Response to NRC Queries of October 28, 1976 for the
Uranium Mill of Atlas Minerals Division of the
Atlas Corporation at Moab, Utah

NRC Ref: FCPF:PAS
40-3453
SUA-917

RESPONSE TO NUCLEAR REGULATORY COMMISSION
QUESTIONS OF OCTOBER 28, 1976
ON ATLAS MINERALS ENVIRONMENTAL REPORT
LICENSE NO. SUA-917

Marley Model No. 4535 R Cooling Tower
(onstream)

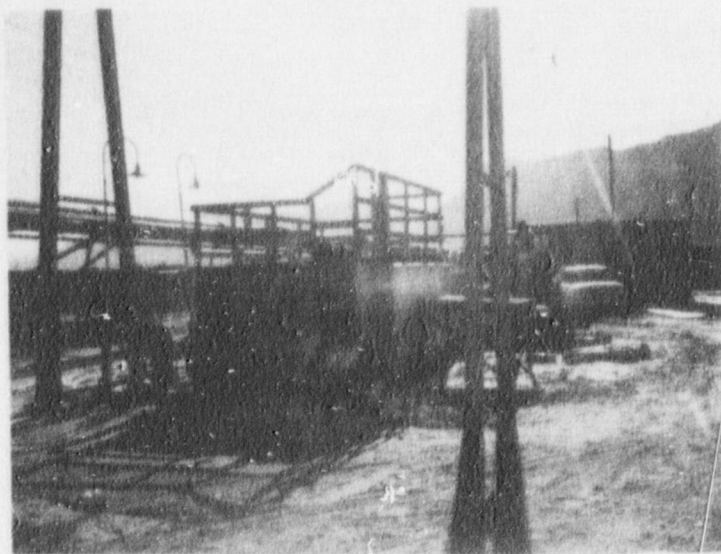
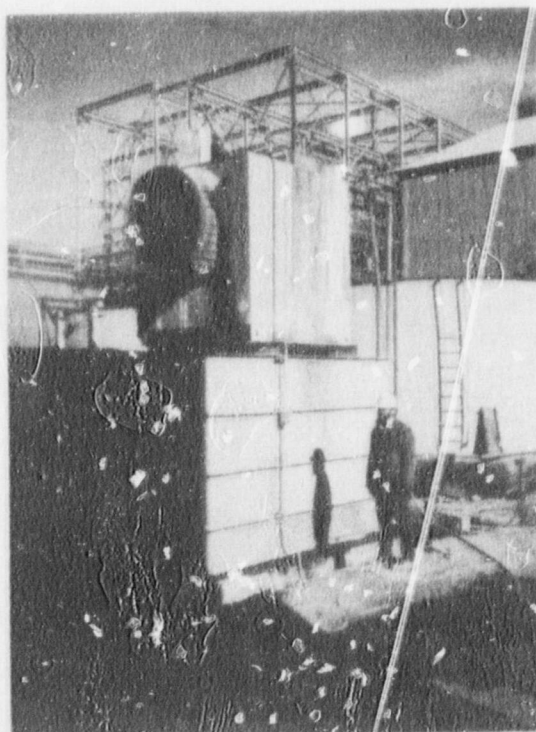
A cooling tower is shown in Plate 7 of the supplement. Please provide all details of the cooling tower and its use, such as heat load, cooling range, flow rate, make-up and blow-down flow rates, disposition of blowdown, etc. (Suppl., Plate 7).

The cooling tower referred to on Plate 7 of the Supplement to ER has been used in the past for cooling of compressors. This particular unit is shown in the accompanying photos in Figure 7. The tower is a Marley Model 13-101, with a cooling flow rate of 150 gpm of water which is cooled from 95° F to 75°F, for an estimated capacity of about 1.5 million BTU's per hour. The unit has exterior dimensions of 16'2" in length, 8'7" in width and 7'9" in height. This unit will be reconditioned and placed on stream as part of the current plant construction. It is estimated that when in operation, this unit will have a bleedwater rate of about 5 gallons per minute. No chemical analyses are available for this bleedstream; however, when again place in operation, this bleedstream will be recycled to the plant process water system.

A second small cooling tower has been placed on stream for the purpose of compressor cooling. This unit, shown in the accompanying Figure 7, is a Marley Aquatower, Model No. 4535 R. It has a 5 horsepower unit which will handle a flow rate of 160 gallons per minute of water across a tempera-

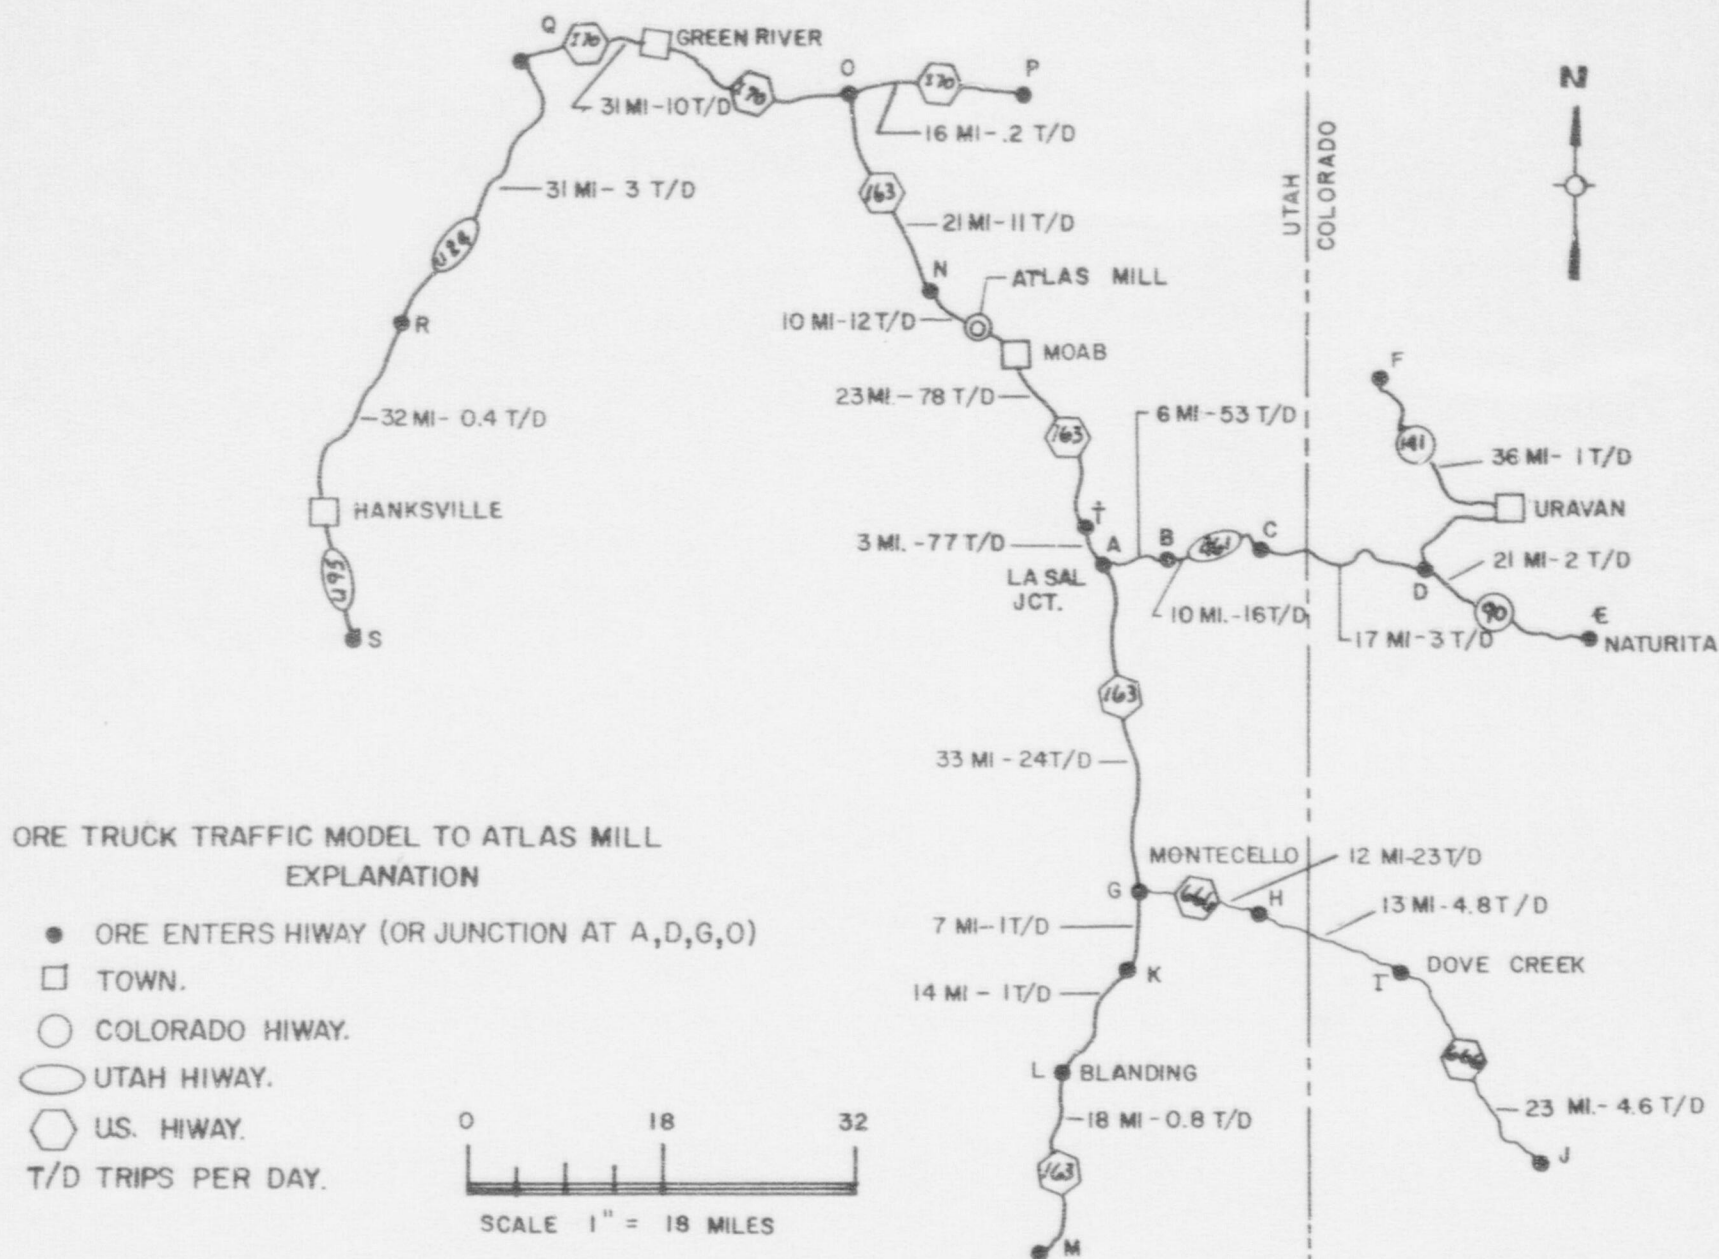
Provide a list of the mines with location that are currently supplying or are expected to supply the uranium ore to the mill (Section 3).

At the meeting with the EIS team on November 16, 1976, it was mutually agreed that the need for such a list lay in the need to develop a truck traffic model. During the life of the mill, ore will be trucked from a continually changing mix of mines. Some mines now in production will be depleted and new reserves will be discovered in others. For this reason, it was suggested and mutually agreed upon that Atlas would develop a suitable model for the truck transport of ore. The reasoning and development of the model is presented below and is illustrated on Figure No. 8, following.

The total shipment from the district was assumed to enter the highway model at this node. On the accompanying Figure 8, these nodes are represented by black dots and are labeled with capital letters B, C, D, and so forth. The nodes A, D, G, and O were located at major highway junctions for convenience in calculating the model. Mileages between nodes were read, or measured, from current highway maps of Utah and Colorado prepared by the H. M. Gousha Co., San Jose, California, as prepared for and distributed by the Chevron Oil Company. Seasonal variations in shipments were adjusted to provide the final model with annual average values. The aggregate monthly tonnage shipped from each district was divided by 27 tons per truckload--the legal maximum on Utah highways--to determine the number of trucks from the district during the month. The number of truck trips between each two nodes was determined and aggregated on a monthly basis. This was multiplied by two to provide for round trips, and was then divided by 30 days/month to provide the trips per day. These trips per day are the values shown on Figure 8.
